Amendments to the Drawings:

REMARKS

FIG. 1

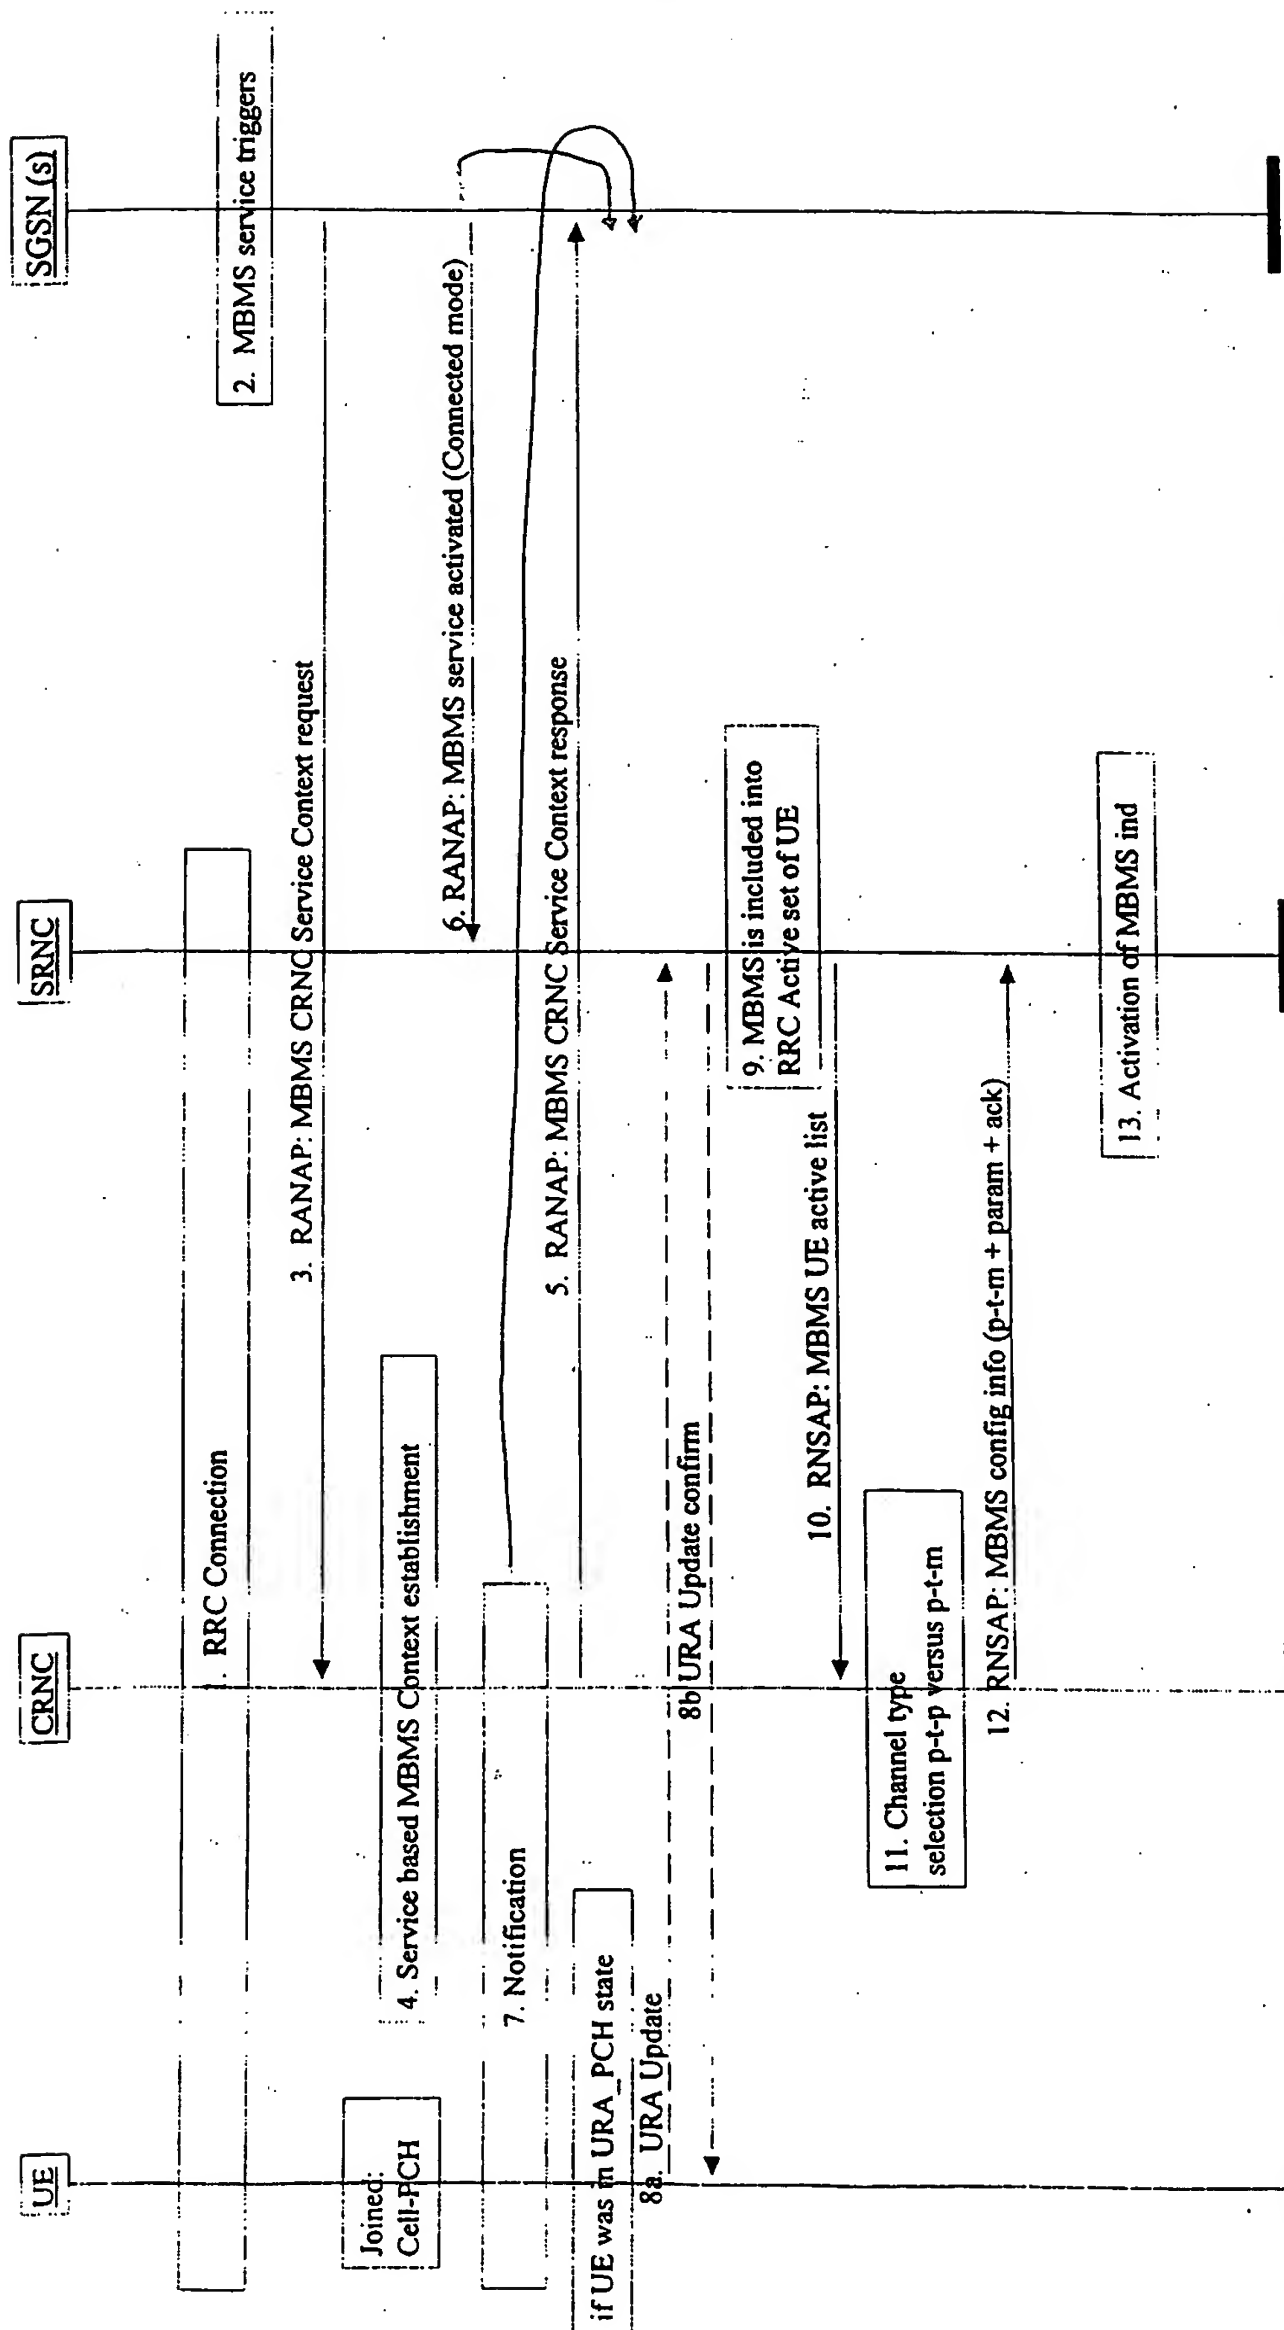
The drawing Figure 1 has been amended. Appended to this amendment is an annotated copy of the previous drawing sheet which has been marked to show changes presented in the replacement sheet of the drawing. Applicant has re-ordered messages 6 and 7 to sequentially follow message 5 as per the Examiner's suggestion.

The Examiner objected to drawing Figure 1 because the visual ordering of messages in Figure 1 was not sequential, i.e., messages 6 and 7 appeared above message 5. In response to the objection, Applicant re-ordered the messages so that messages 6 and 7 appear below message 5. No new matter is being added with this amendment to the drawings.
